Safety Evaluation Report

related to the operation of
Midland Plant,
Units 1 and 2

Docket Nos. 50-329 and 50-330

Consumers Power Company

Figure 3.1 Reinforced concrete ring beam for

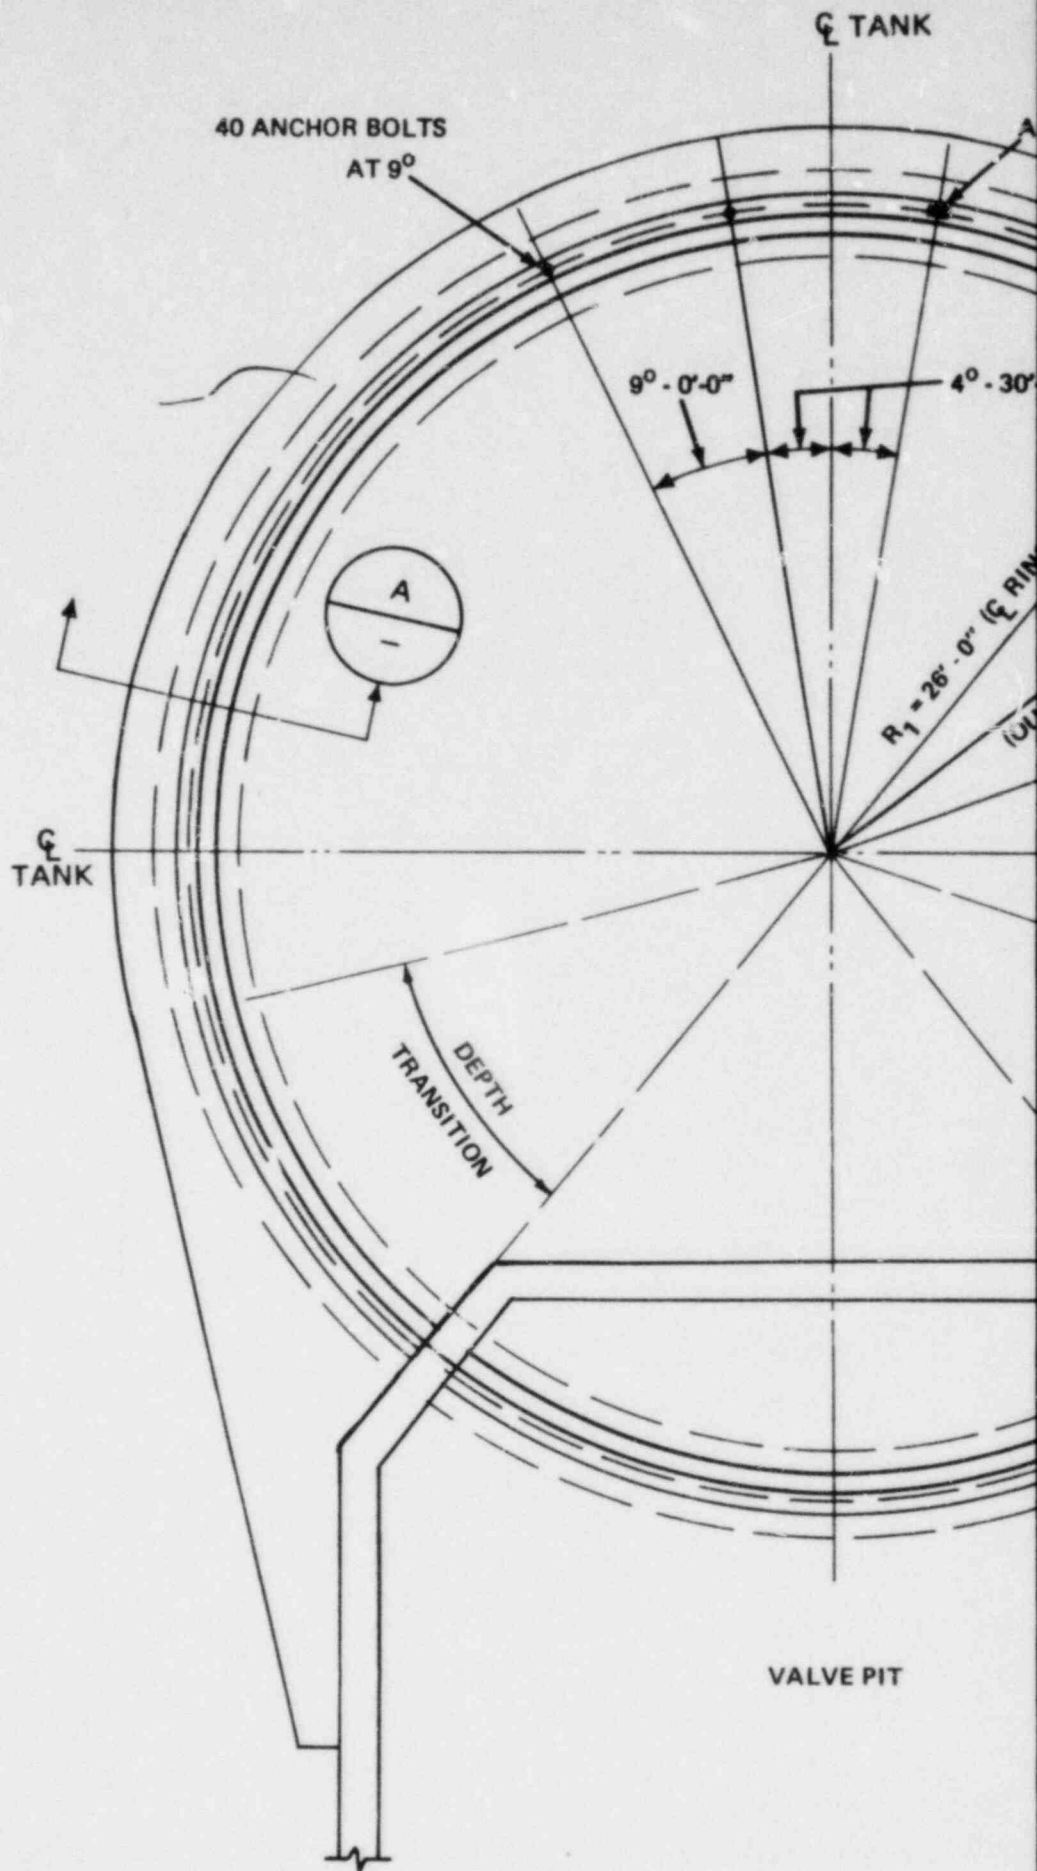
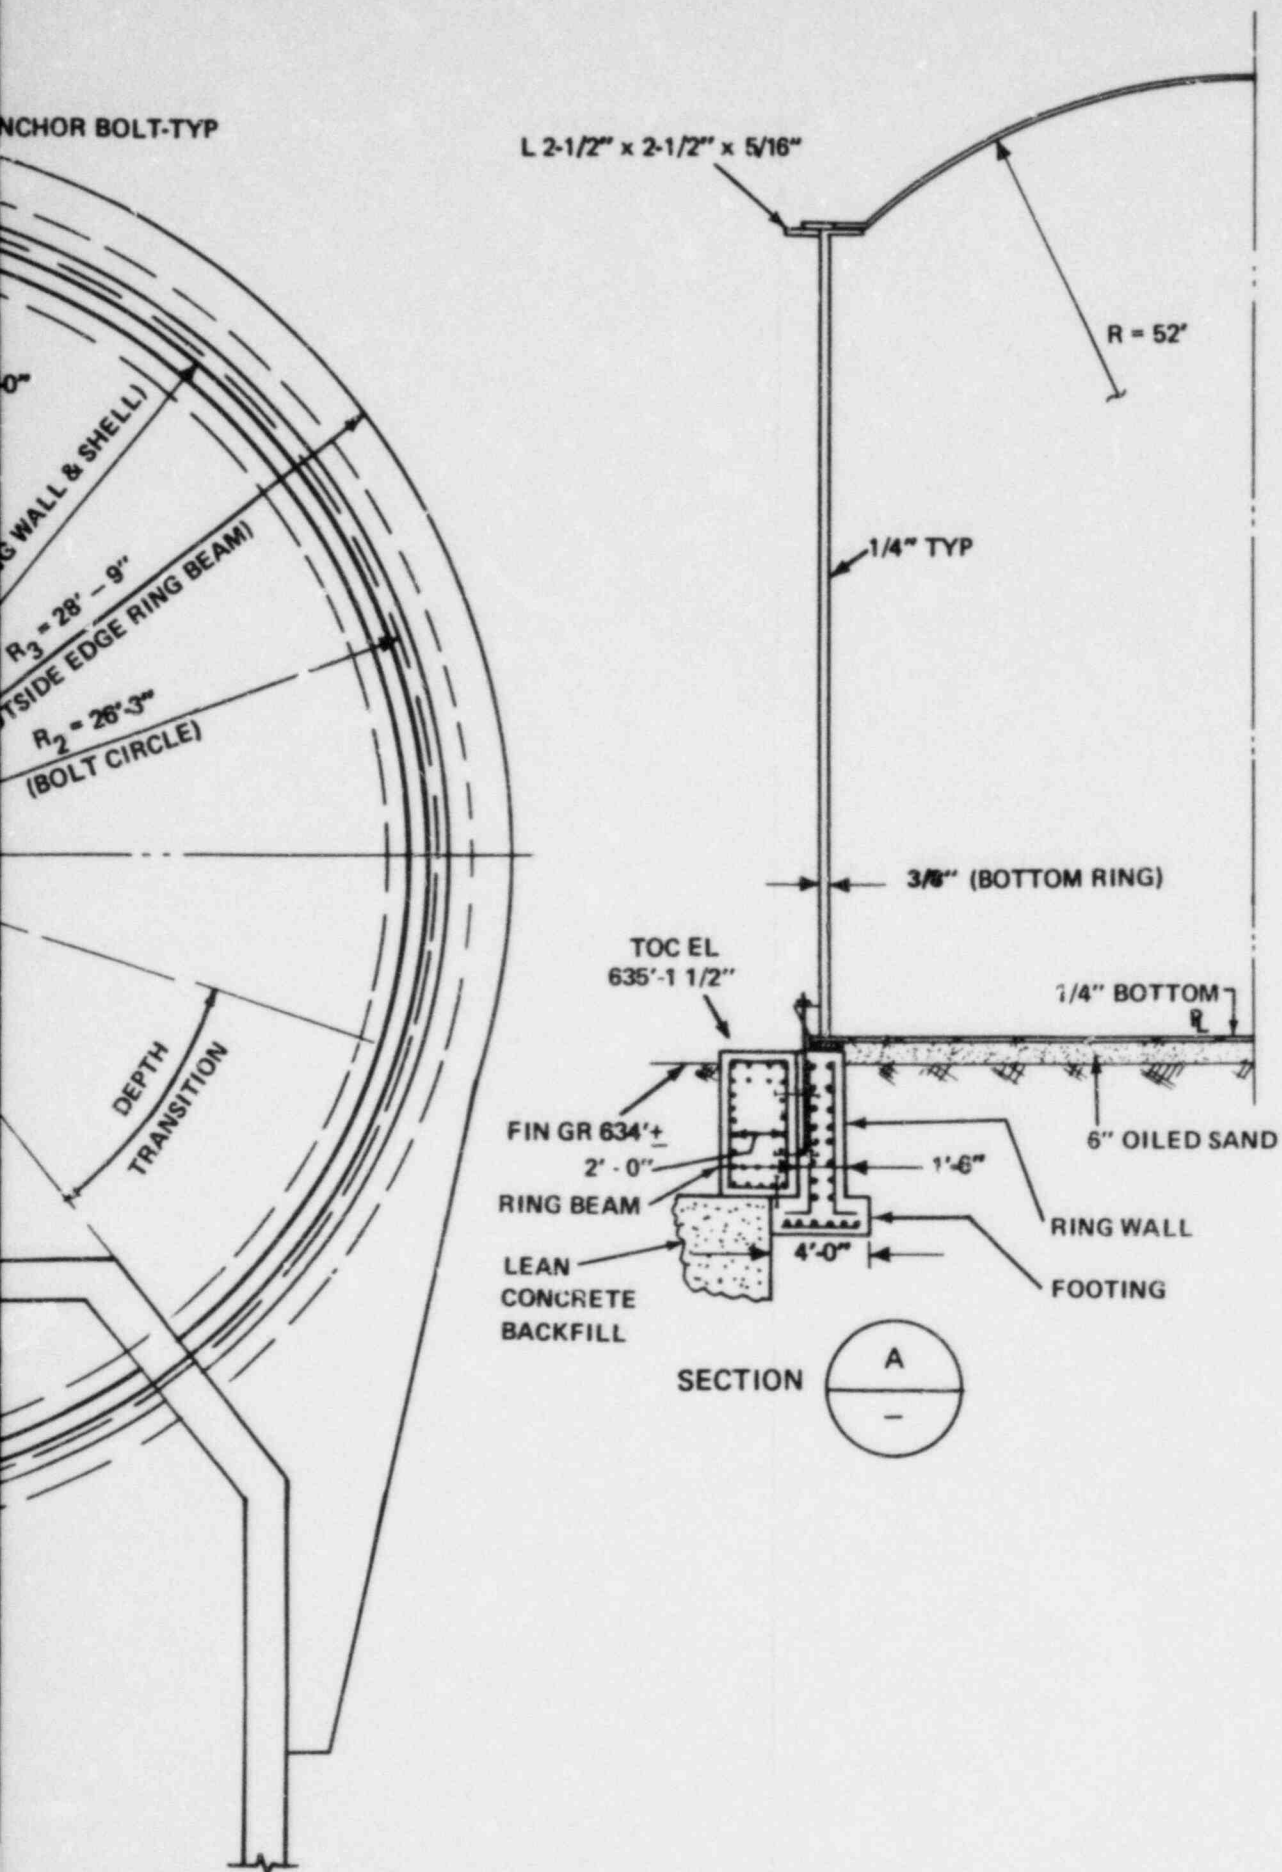
The new reinforced concrete ring beam to be added to each tank foundation as a foundation design correction is shown in Figure 3.1 of this SSER. The ring beam will be 2 ft wide and 4 ft 6 in. deep and will be located on top of the exterior footing projection. A depth and width transition will be located adjacent to the valve pit that is similar to the transition zone of the ring wall. A portion of the ring beam 1 ft 6 in. wide and 3 ft 6 in. deep will extend through the valve pit. A portion of the reinforcing bars will extend through the valve pit embedded in a 5-in.-thick slab added on top of the original valve pit floor slab. The 5-in.-thick slab will connect to the floor slab by 1-in.-diameter anchor bolts grouted into holes drilled in the floor slab. The portion of the ring beam reinforcing bars that does not extend through the valve pit will be grouted into holes drilled in the valve pit slabs. Steel bolts with nuts will be used to connect the ring beam to the ring wall and the valve pit.

Figure 6.1 Peak cladding temperature for worst case small-break loss-of-coolant accident (0.07-ft² cold leg)

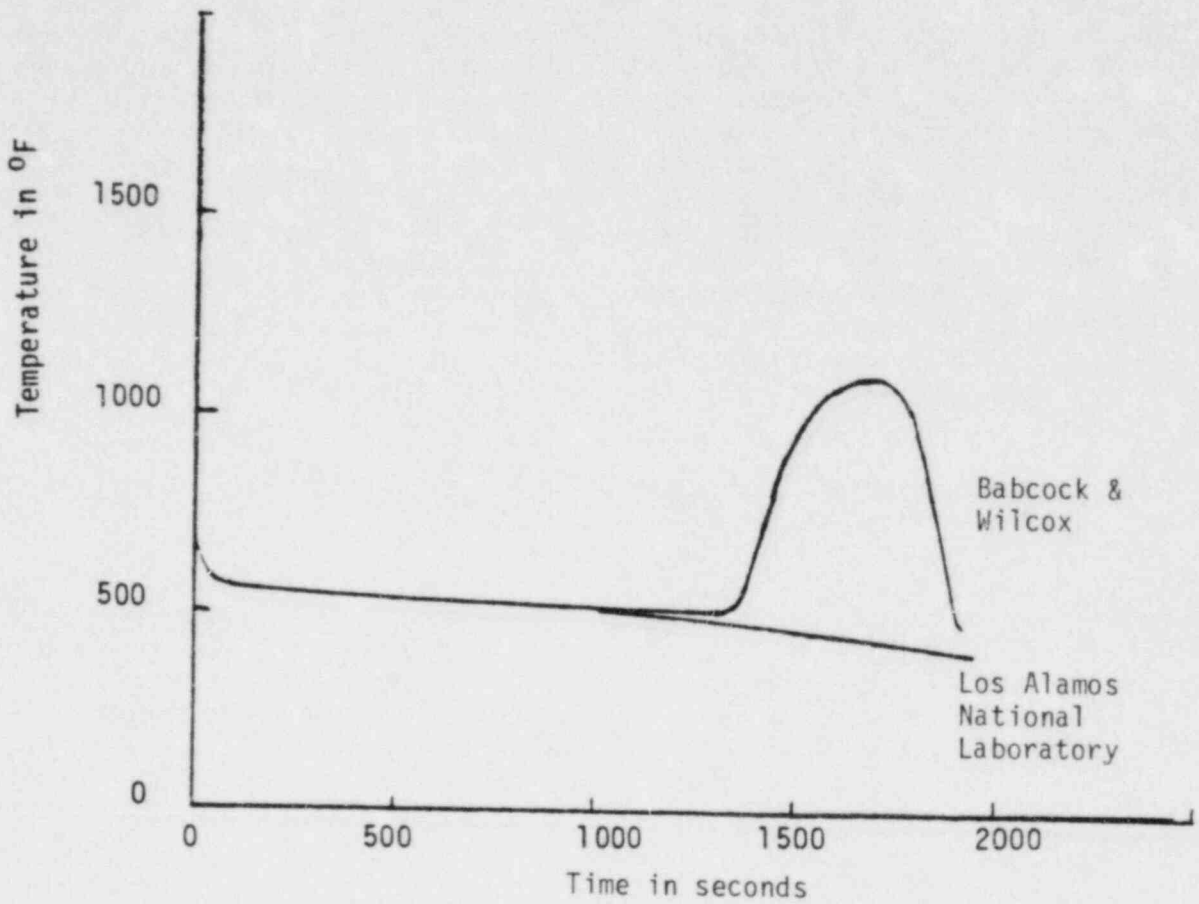
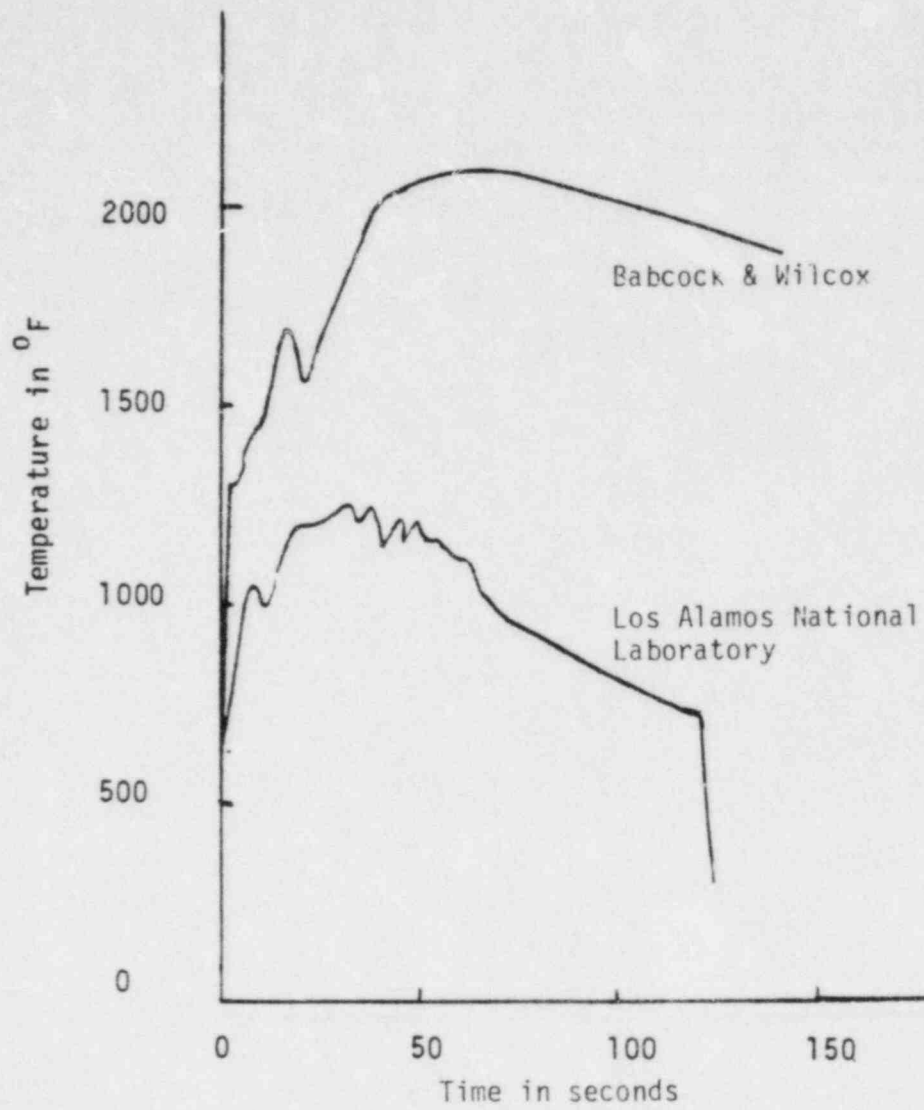
To provide further confirmation that the Appendix K requirements are as conservative as originally intended, the NRC staff contracted with LANL to perform best estimate analyses of the large- and small-break sizes determined by the applicant to produce the most severe conditions of core uncover and cladding heatup. Best estimate analyses assume expected values of decay heat, heat transfer, and fluid flow based on experimental data. Also, emergency core cooling systems (ECCSs) are assumed to be fully operational. Appendix K requires conservative decay-heat, heat transfer, and fluid-flow assumptions. The B&W LOCA model also assumes degraded ECCS flow to demonstrate redundancy as required by GDC 35. The peak cladding temperature results from the LANL analyses and those predicted by the B&W evaluation model are presented in Figures 6.1 and 6.2 of this SSER.

These results indicate that the applicant's large-break analysis is conservative by 850°F and that the small-break analysis is conservative by 650°F. Although

these values are estimates, subject to the uncertainties of the computer models and actual initial and boundary conditions, they are nevertheless useful in demonstrating the relative margin that is provided by Appendix K conservatism. They also help confirm that these Appendix K assumptions provide the conservatism they were originally intended to provide.

Figure 1.3 Jacking sequence
(Source: Mergent)

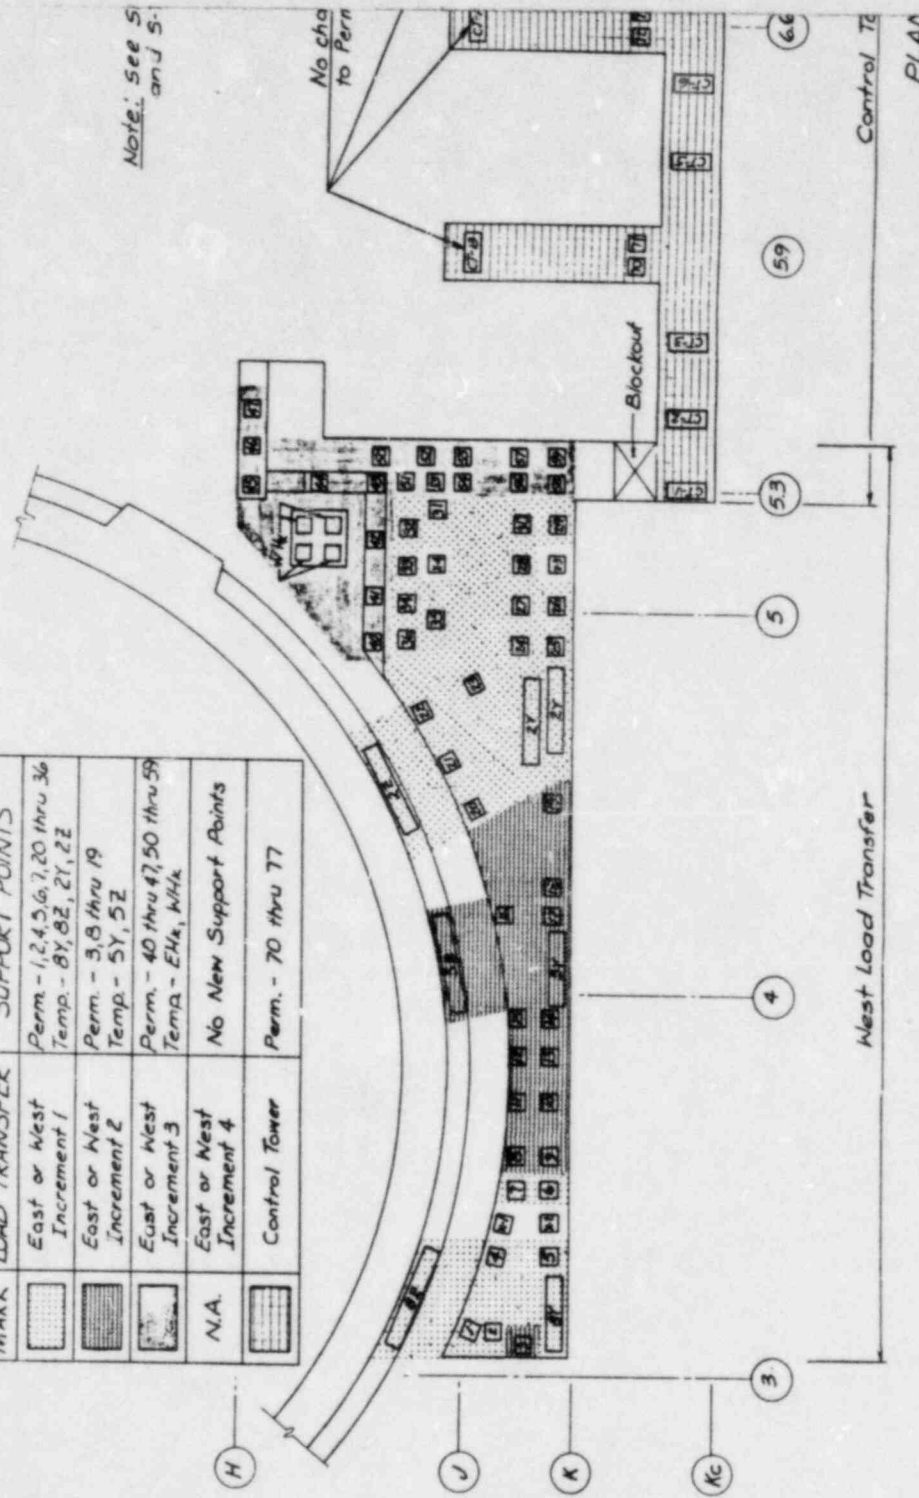
The present plans for the permanent wall load transfer jacking sequence are shown on Figures I.3 of this SSER. Variations in the present plan may be implemented, subject to prior NRC approval, as early construction data are obtained and assessed.
